ECE/TRANS/WP.15/256/Add.1

**Draft amendments to annexes A and B of ADR**

**Addendum**

This document contains the requested additional list of amendments adopted by the Working Party at its 111th session.

“6.8.3.2.9.6 Safety valve mark

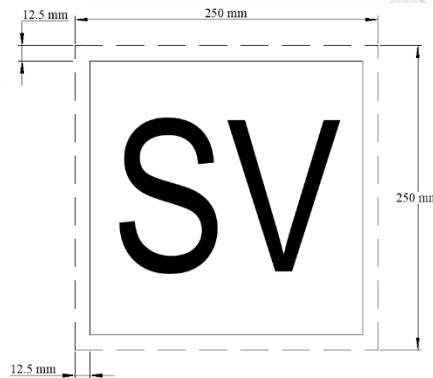
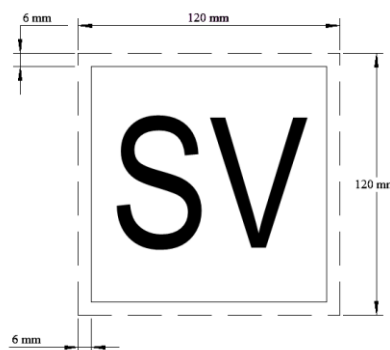
6.8.3.2.9 Insert the following new 6.8.3.2.9.6:

6.8.3.2.9.6.1 Tanks fitted with safety valves in accordance with 6.8.3.2.9.1 to 6.8.3.2.9.5 shall display the mark as set out in 6.8.3.2.9.6.3 to 6.8.3.2.9.6.6.

6.8.3.2.9.6.2 Tanks not fitted with safety valves in accordance with 6.8.3.2.9.1 to 6.8.3.2.9.5 shall not display the mark as set out in 6.8.3.2.9.6.3 to 6.8.3.2.9.6.6.

6.8.3.2.9.6.3 The mark shall consist of a white square with minimum dimensions of 250 mm × 250 mm. The line inside the edge shall be black, parallel and approximately 12.5 mm from the outside of that line to the outside edge of the mark. The letters "SV" shall be black, a minimum of 120 mm high and have a minimum stroke thickness of 12 mm.

with a capacity of not more than 3 000 litres the mark may be reduced in size to not less than 120 mm × 120 mm. The line inside the edge shall be black, parallel and approximately 6 mm from the outside of that line to the outside edge of the mark. The letters "SV" shall be black, a minimum of 60 mm high and have a minimum stroke thickness of 6 mm.

6.8.3.2.9.6.5 The material used shall be weather-resistant and it shall be ensured that the mark is durable. The mark shall not become detached from its mount in the event of 15 minutes' engulfment in fire. It shall remain affixed irrespective of the orientation of the tank.

6.8.3.2.9.6.6 The letters "SV" shall be indelible and shall remain legible after 15 minutes' engulfment in fire.

6.8.3.2.9.6.7 The marks shall be displayed on both sides and the rear of fixed tanks (tank-vehicles) and on both sides and both ends of demountable tanks.

The marks shall be displayed on both sides and both ends of tank-containers. For tank-containers with a capacity of less than 3 000 litres the marks may be displayed either on both sides or on both ends.
